**CALIFORNIA COASTAL COMMISSION**

#### STAFF REPORT: REGULAR CALENDAR

**APPLICATION NUMBER:** 5-02-153

**PROJECT DESCRIPTION:** Conversion of an existing two-story, 1,620 square foot single family residence into an accessory structure (by removing kitchen), and construction of a 30-foot high, two-story, 2,500 square foot single family residence and a detached two-car garage across two abutting canal-front lots.

EXHIBIT # 4

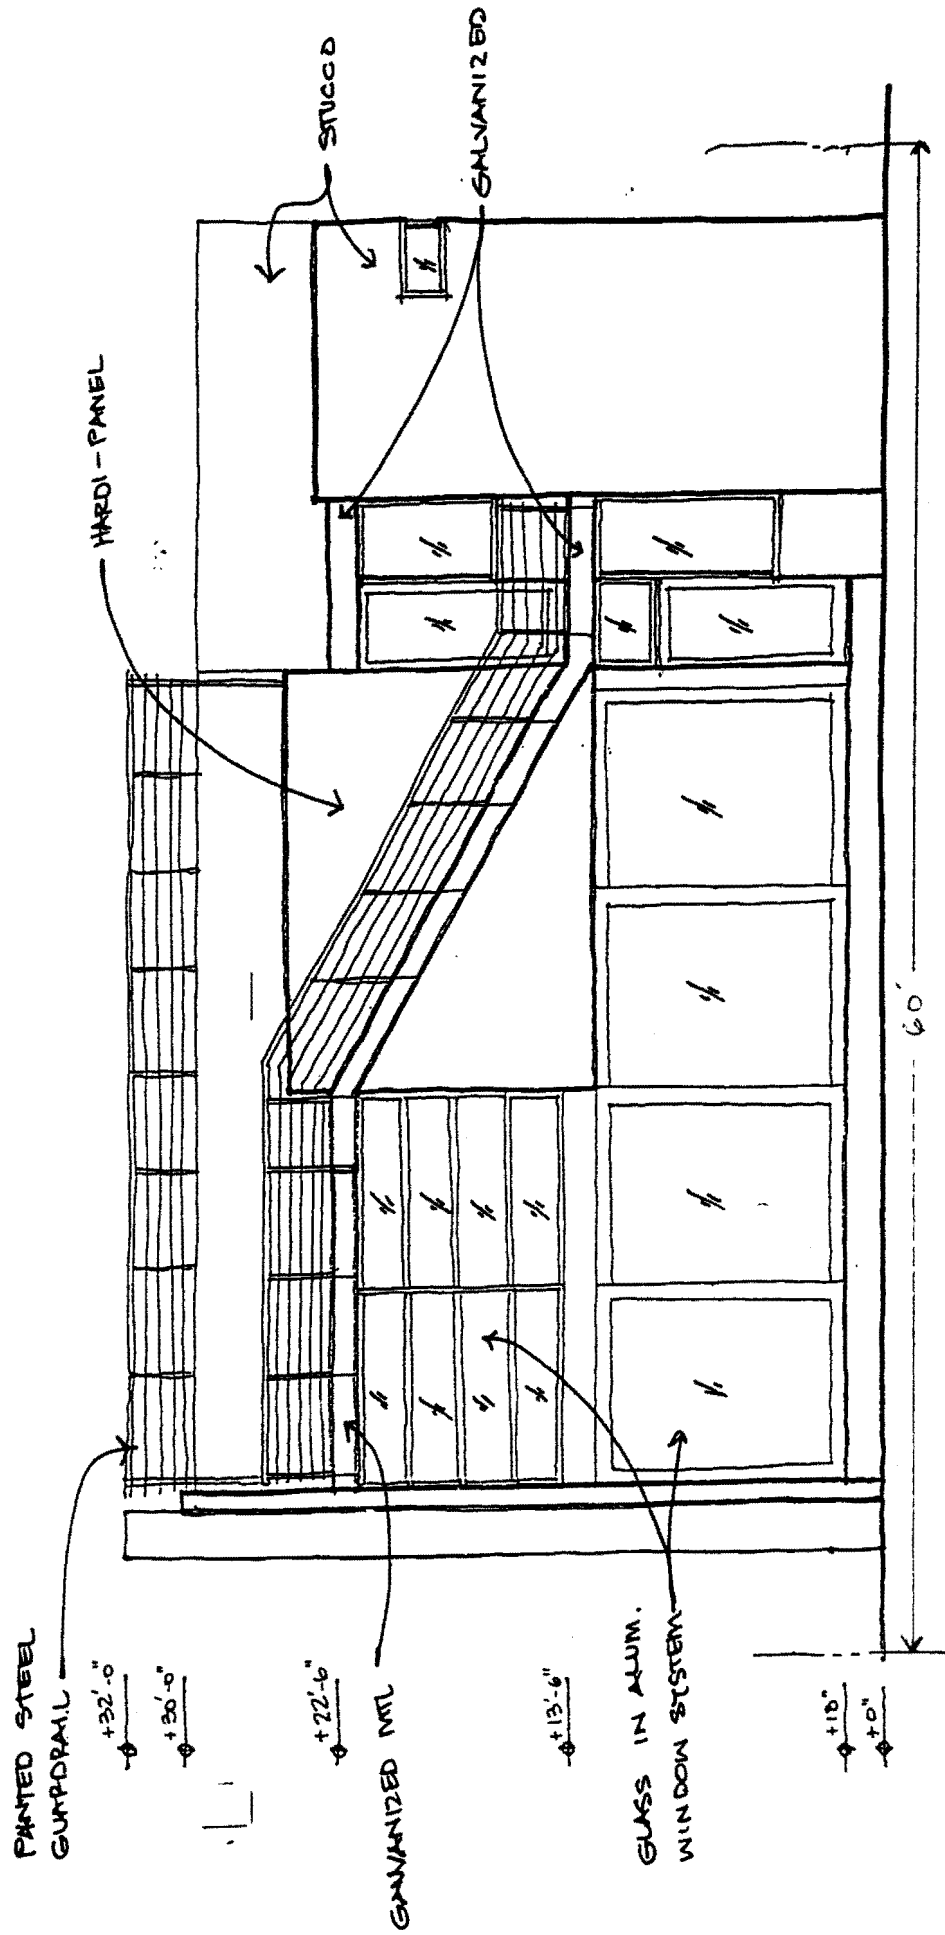
In this case, the proposed single family residence does not provide the required fifteen-foot average setback between the house and the front (Grand Canal) property line (Exhibit #4). The proposed house is set back thirteen feet from the canal property line, leaving about 850 square feet of permeable front yard area between the front of the house and the canal property line. For the two thirty-foot wide lots, the amount of permeable yard area that must be maintained between the canal property line and the front of the house would be 900 square feet (two times the required 450 square feet for one thirty-foot wide lot). The proposed project does not provide all of the permeable front yard area required by the certified Venice LUP, and is inconsistent with the marine resource and water quality provisions of the Coastal Act.

The proposed project provides three on-site parking spaces: two in a proposed garage and one uncovered space next to the garage (Exhibit #4). The proposed three parking spaces would be an adequate parking supply for a single family residence. The proposed project, however, involves one existing single family residence (1,620 square feet) and one proposed single family residence (2,500 square feet). The existing single family residence, which would be remodeled and redefined as an accessory structure, is proposed to remain on the site with no additional parking provided. Although the kitchen is proposed to be removed from the existing single family residence, the use of the structure by guests would increase the parking demand for the site. At least one additional on-site parking space should be required to serve the 1,620 square foot residential structure that currently occupies the site. The proposed three parking spaces do not provide an adequate parking supply to meet the demand of the

EXHIBIT # 5

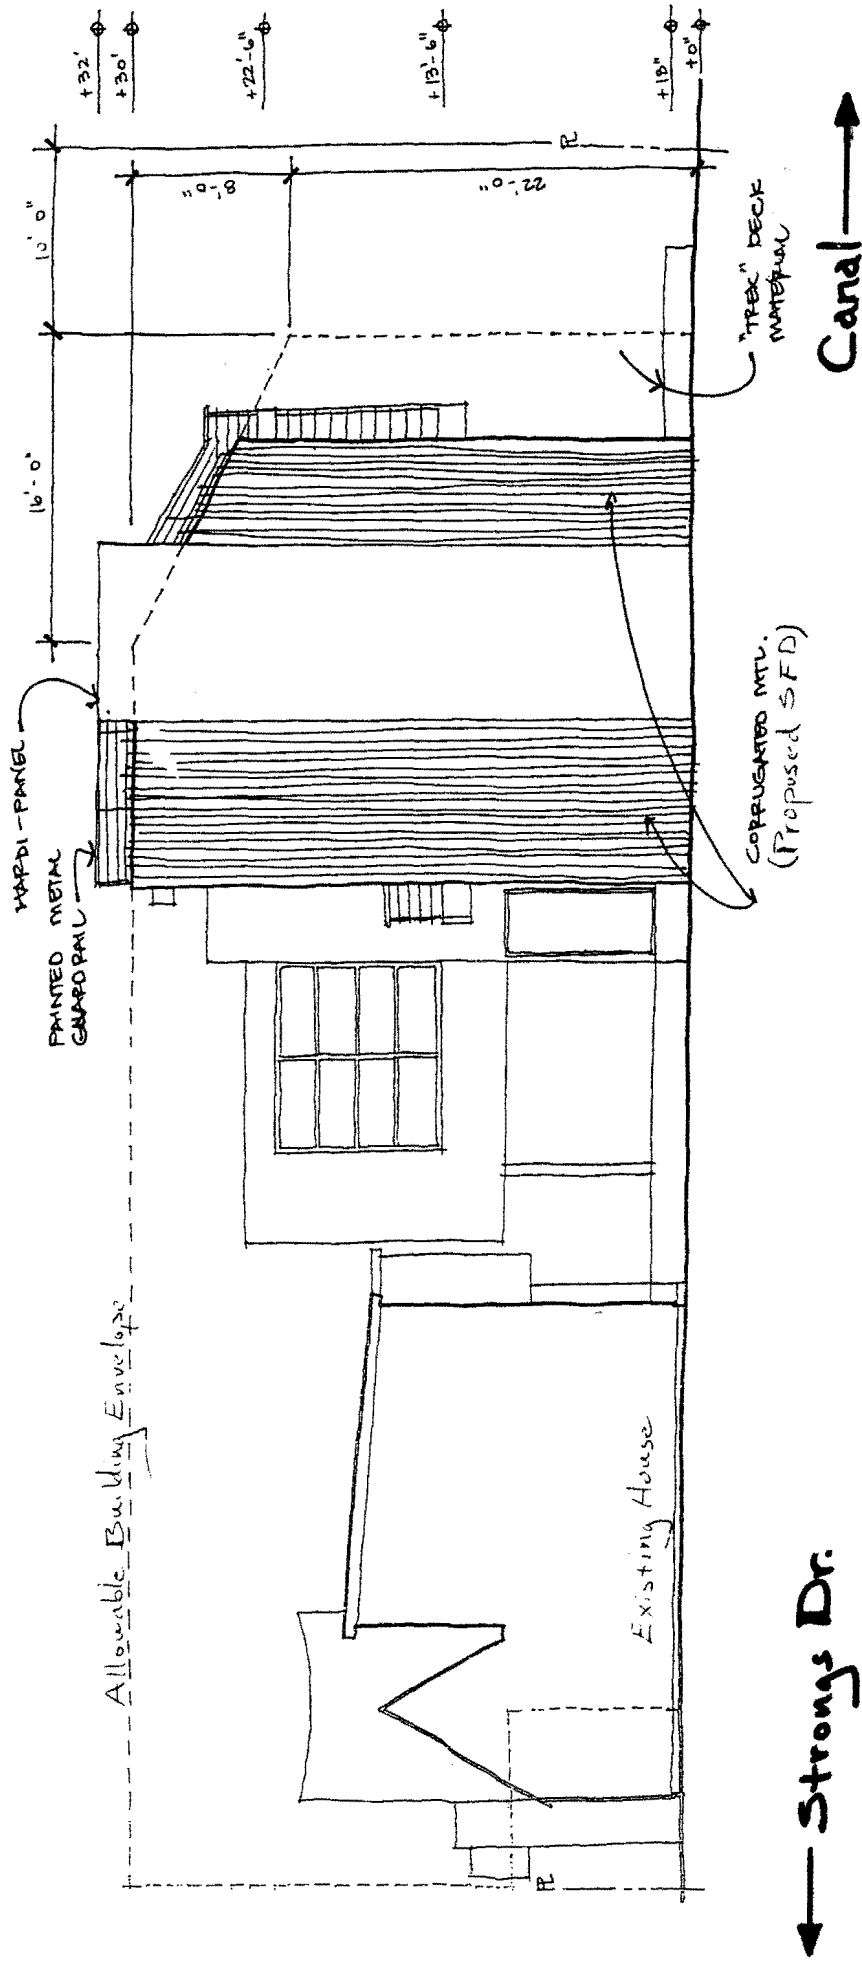
faces the canal (See Appendix A). Moreover, the façade of the proposed house is almost as wide as the canal, which is fifty feet wide. The proposed metal and glass façade is so massive that it would dominate its canal-side setting (Exhibit #5). Also, the proposed house does not provide the required fifteen-foot average setback from the canal property line, as required by the certified Venice LUP. Therefore, the design of the proposed project is not in character with the surrounding area, is out of proportion with the public resource, and the proposed development is inconsistent with Sections 30251 and 30253(5) of the Coastal Act and prior Commission actions.
